**ADDENDUM NO. 3****DATE:** MARCH 24, 2022**CONTRACT NO.:** HU-0029-B01**PROJECT:** UNION CITY - NEW GRADE 7 THROUGH 9 SCHOOL

DESCRIPTION: **Union City - New Grade 7 through 9 School**
 Union City, NJ
 Addendum No. 3

DRAWING TITLE
**PROPOSED
GRADING,
DRAINAGE AND
UTILITY PLAN**

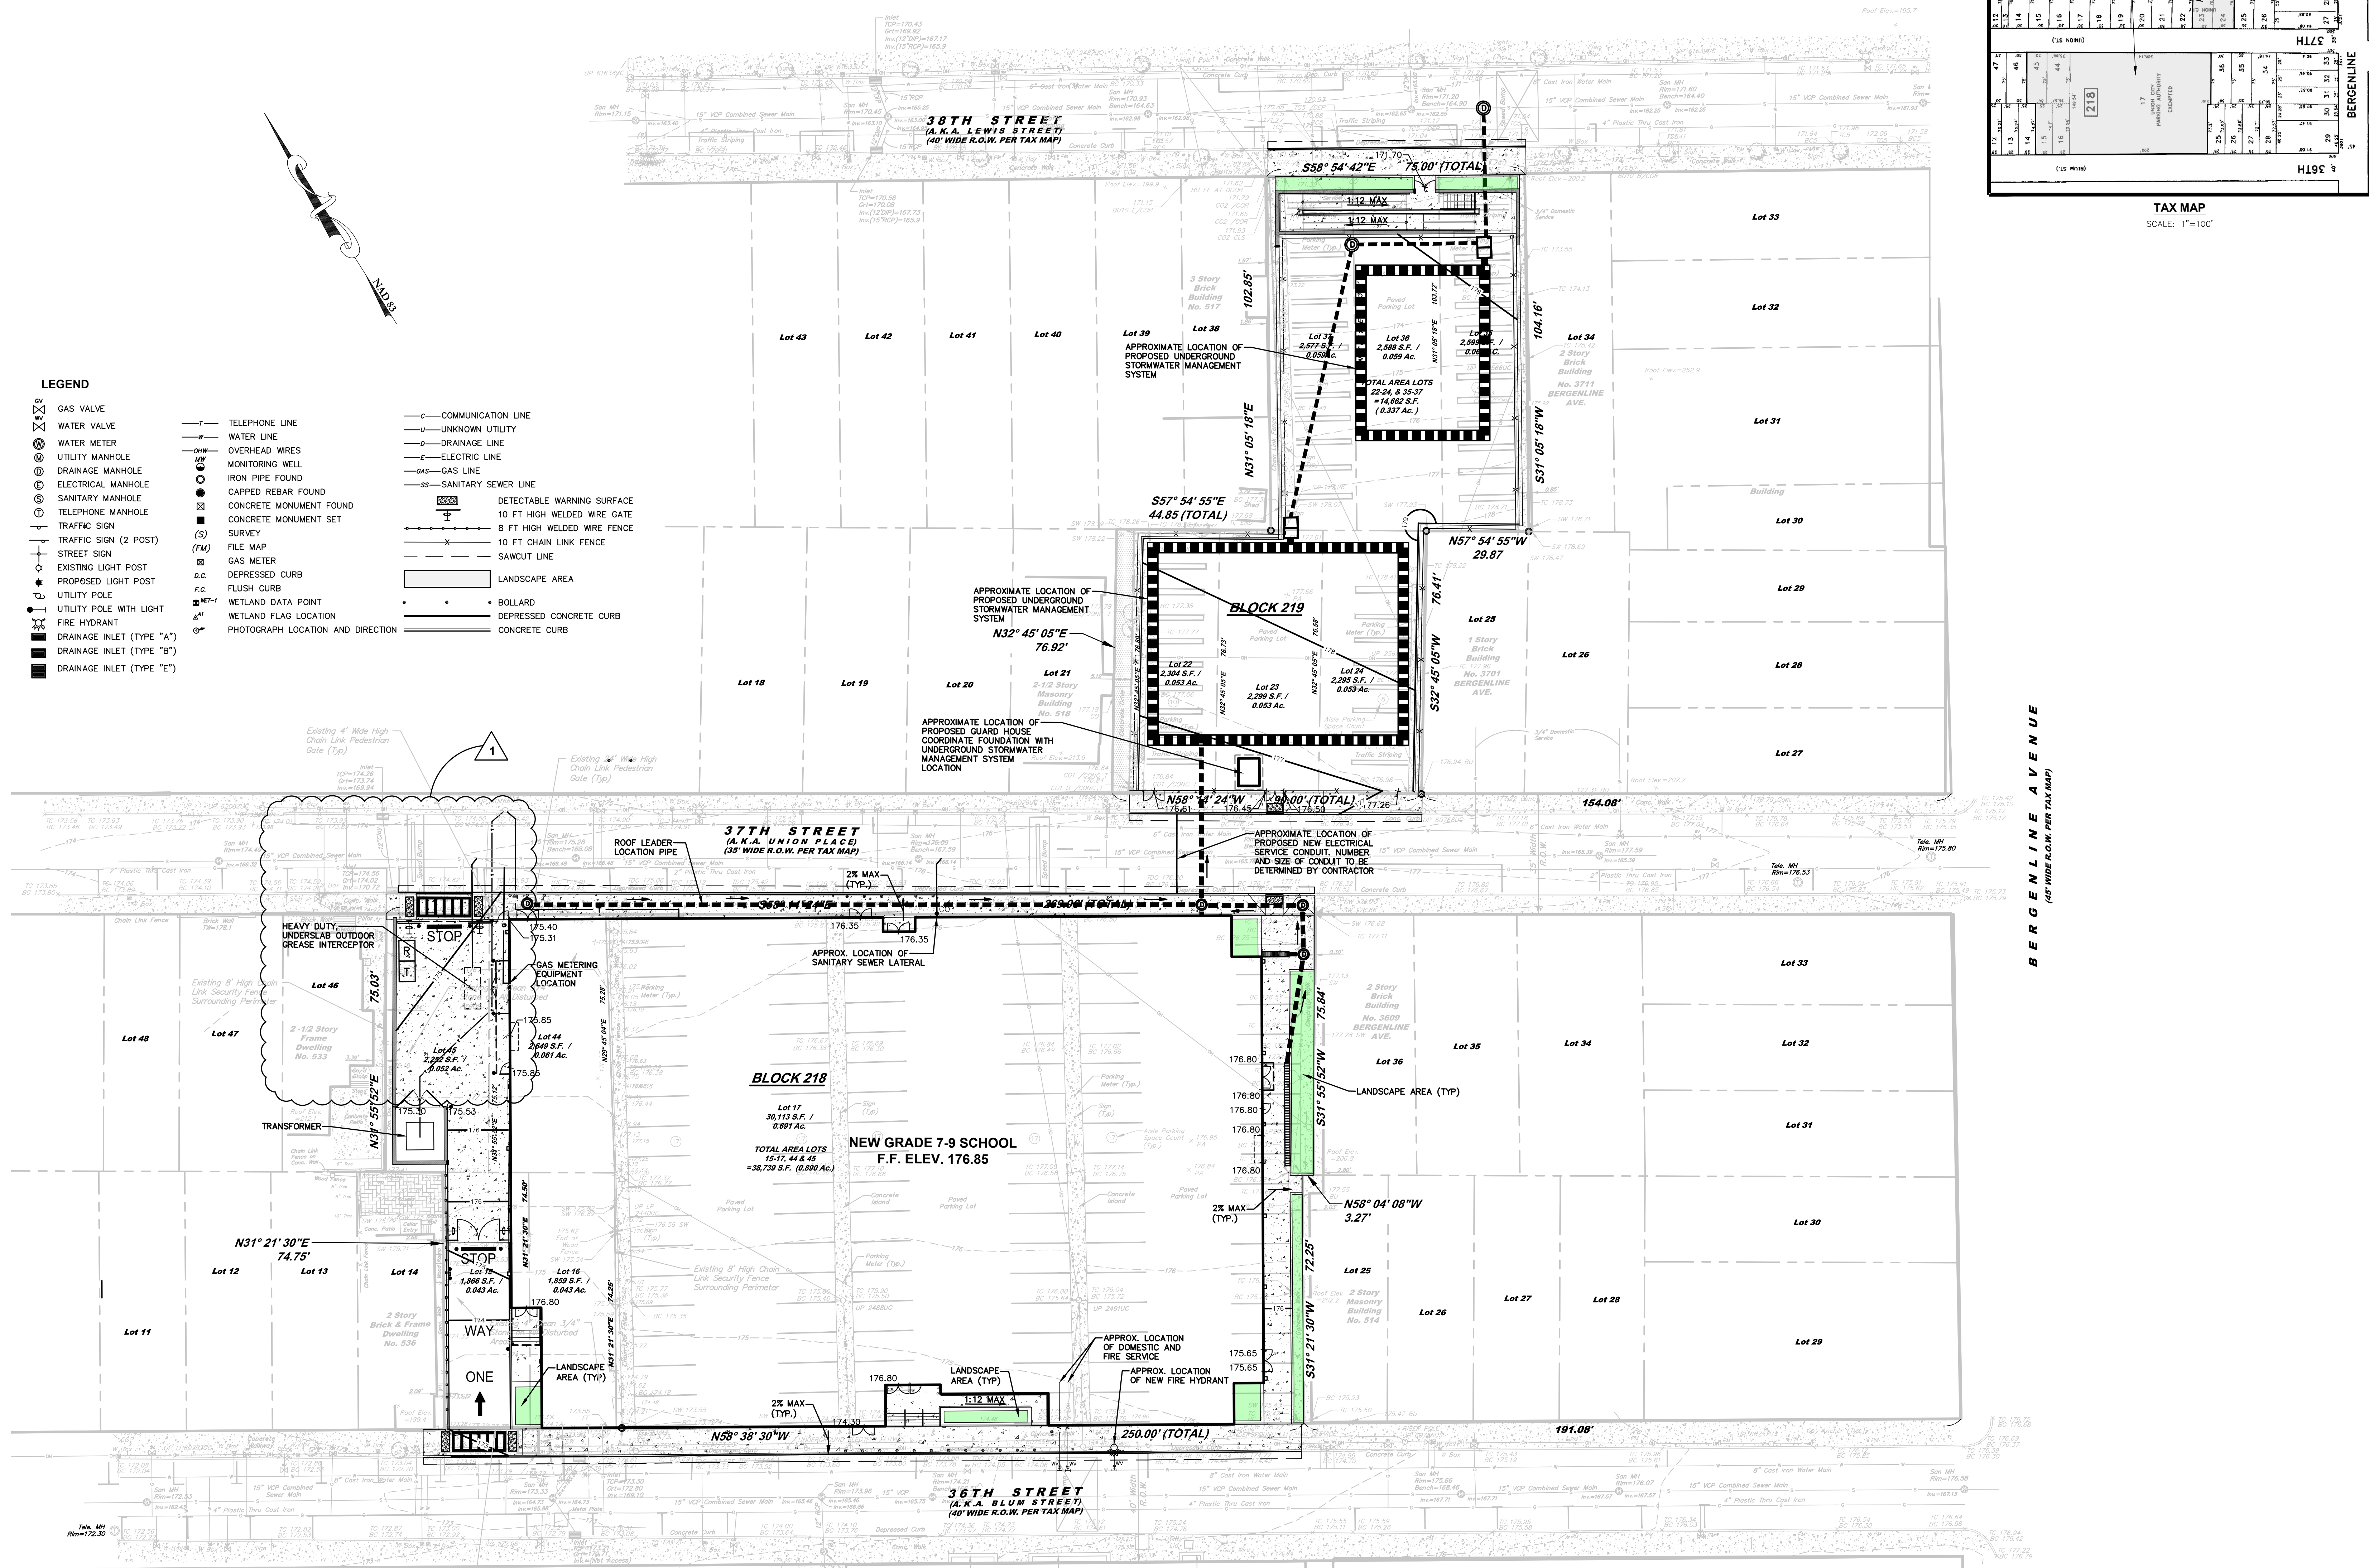
23. **Question:** Please confirm the design intent for the location of the grease trap for the kitchen. Will there be a central outdoor or indoor trap, or is the design intent to have multiple strategically located grease traps? (BQ27)

Response: The intent is a single grease interceptor located outdoors, underneath the Delivery / Service Area. See the revised drawing C-201, attached, Proposed Grading, Drainage and Utility Plan.

A FOOD SERVICE PLAN
SCALE: 1/4" = 1'-0"

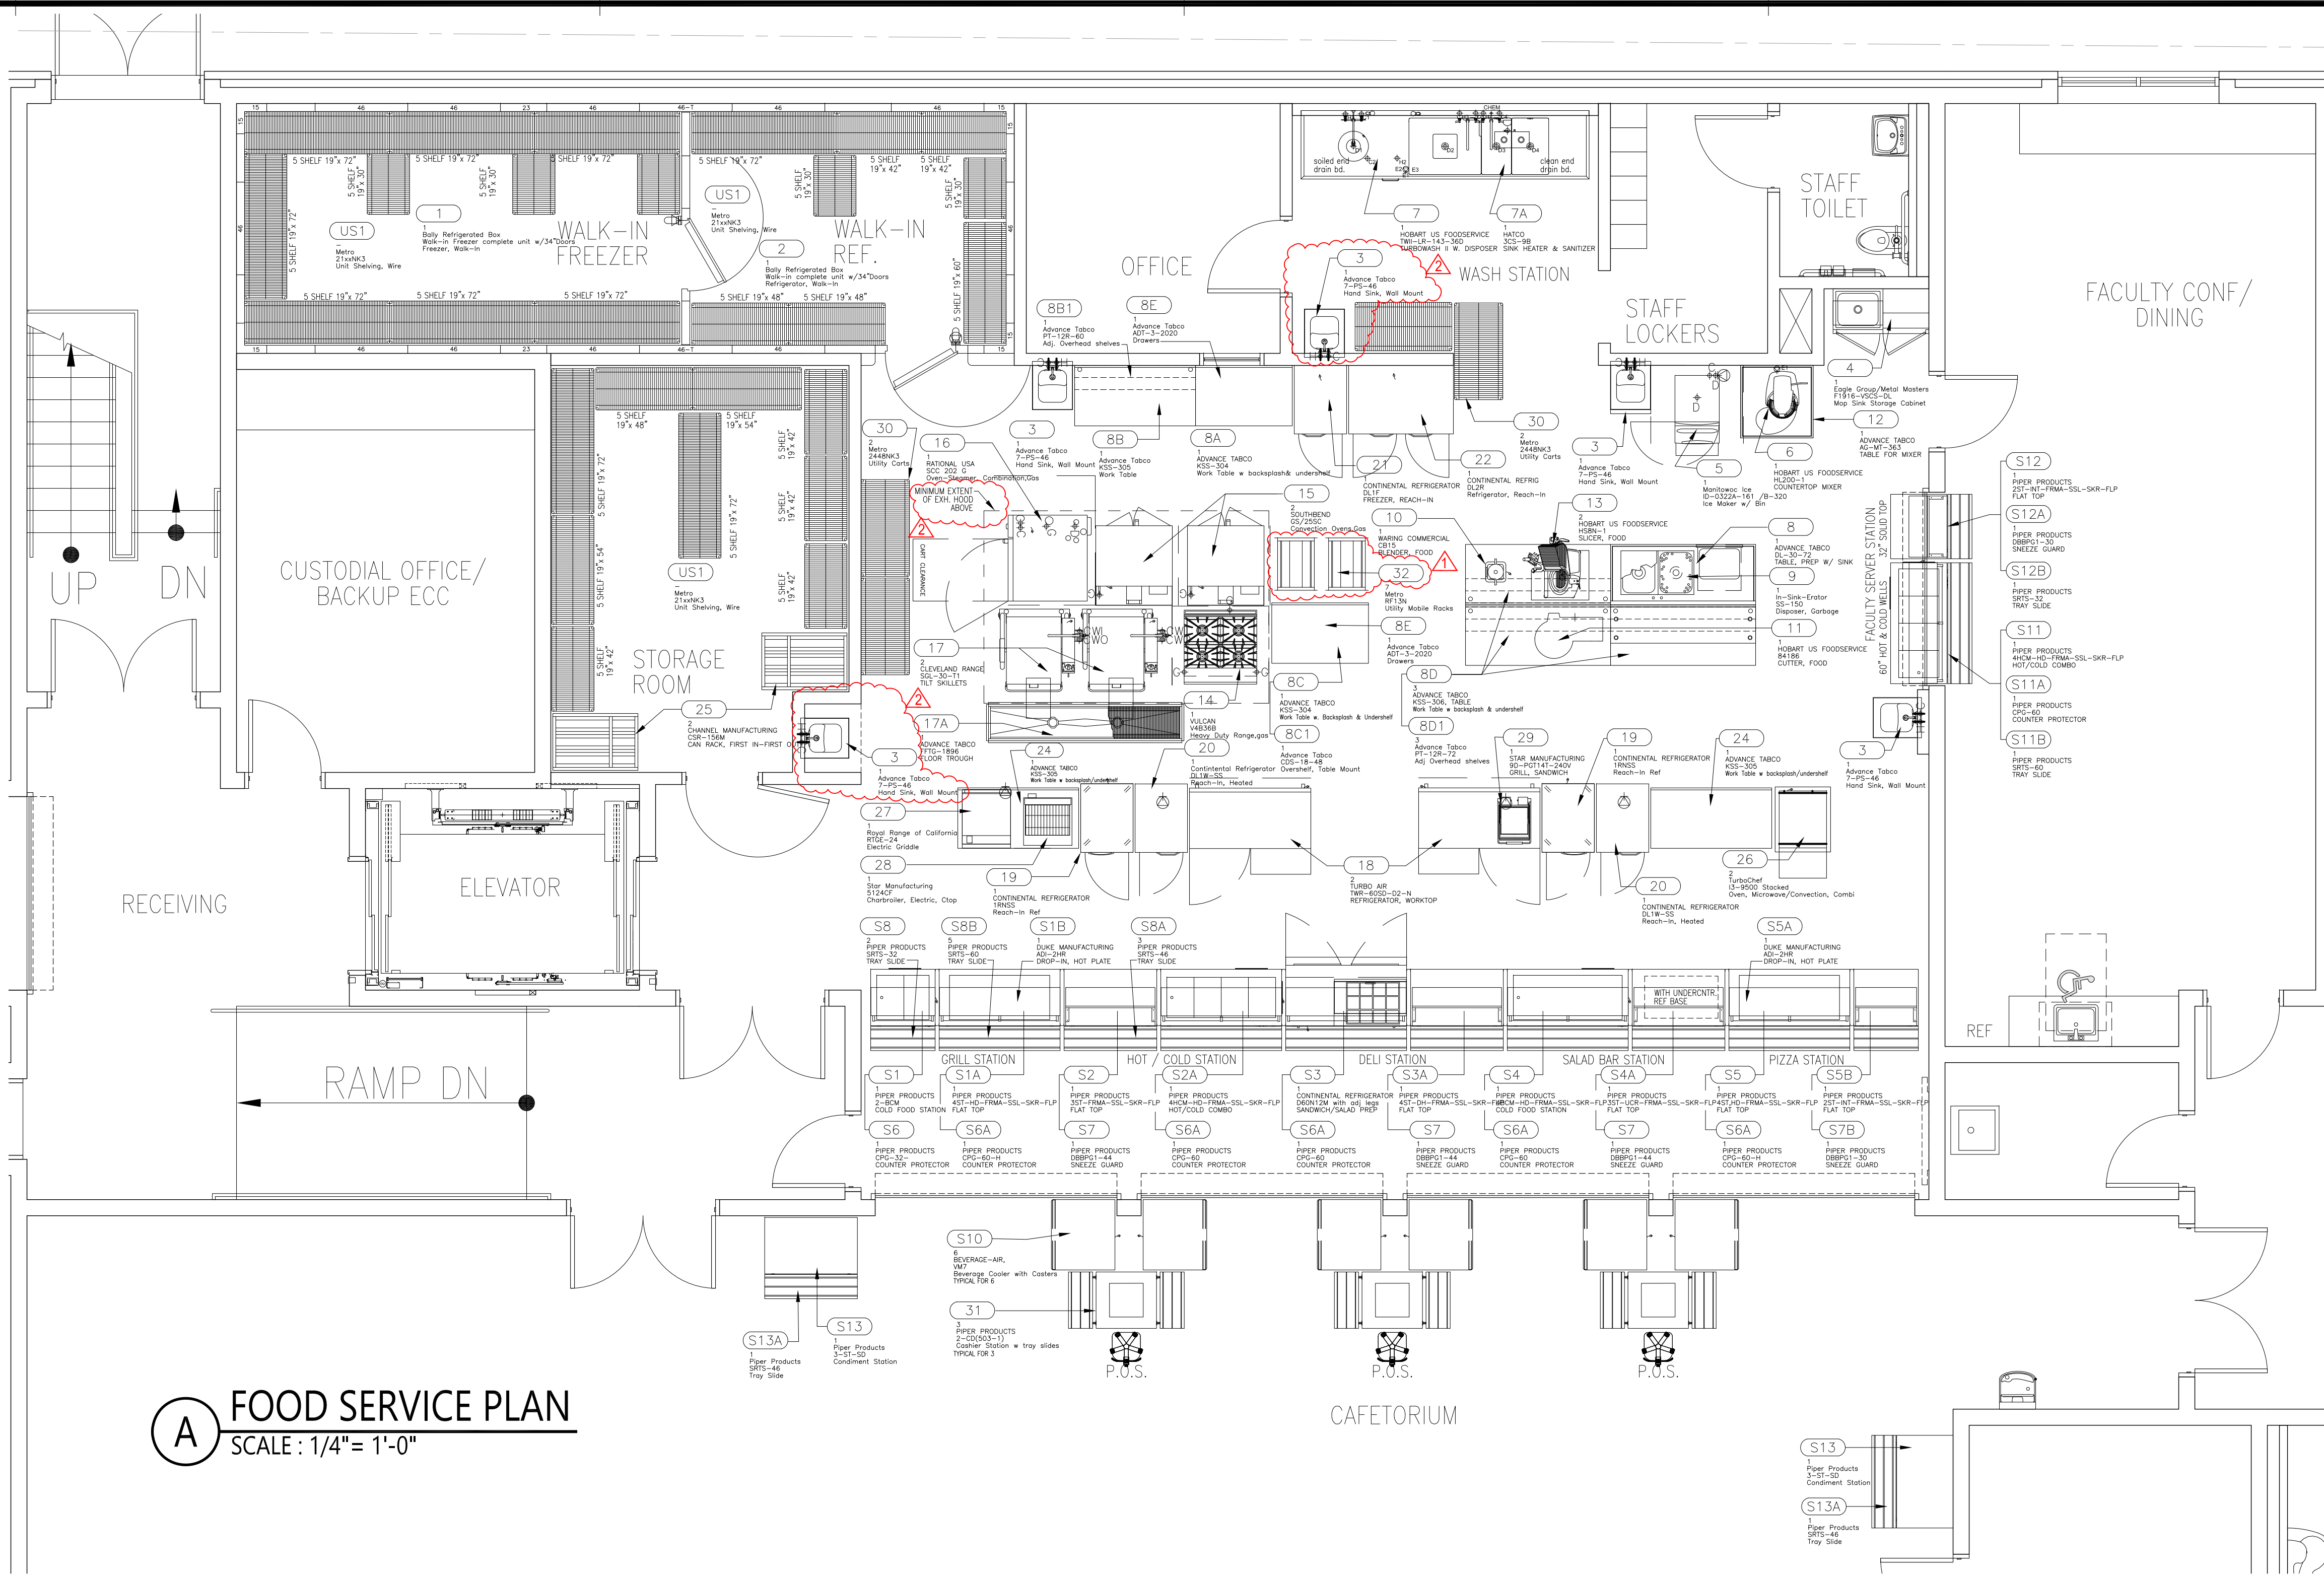
- Response:** Confirmed, pass through refrigerators and heated cabinets are not required.
18. **Question:** The Health code states "Handwashing facilities shall be adequate in size and number and shall be so located and maintained as to permit convenient and expeditious use by all employees". There are two specific instances that this criteria does not seem to be met. The first is within the Wash Station room, and the second is at the left side of the serving line. There is no hand wash station in the general vicinity. It is suggested that a hand wash station be added on the storage room wall which could serve the left portion of the serving line and a hand sink to be added within the Wash Station room. (BQ22)

20. **Question:** The Combination Oven-Steamer item number 16 is turned 90° from the other cooking equipment. In order for the exhaust hood to capture steam from the oven cavity when the door is opened the hood will need to extend another 12 inches from what is shown on the DBIP documents. Please confirm this is acceptable. (BQ24)

Response: A handwashing sink has been added in the vicinity of the wash station and left end of the serving line. See the revised drawing A-801 Food Service Plan and Equipment Schedule.

Response: Confirmed. See the revised drawing A-801 Food Service Plan and Equipment Schedule.
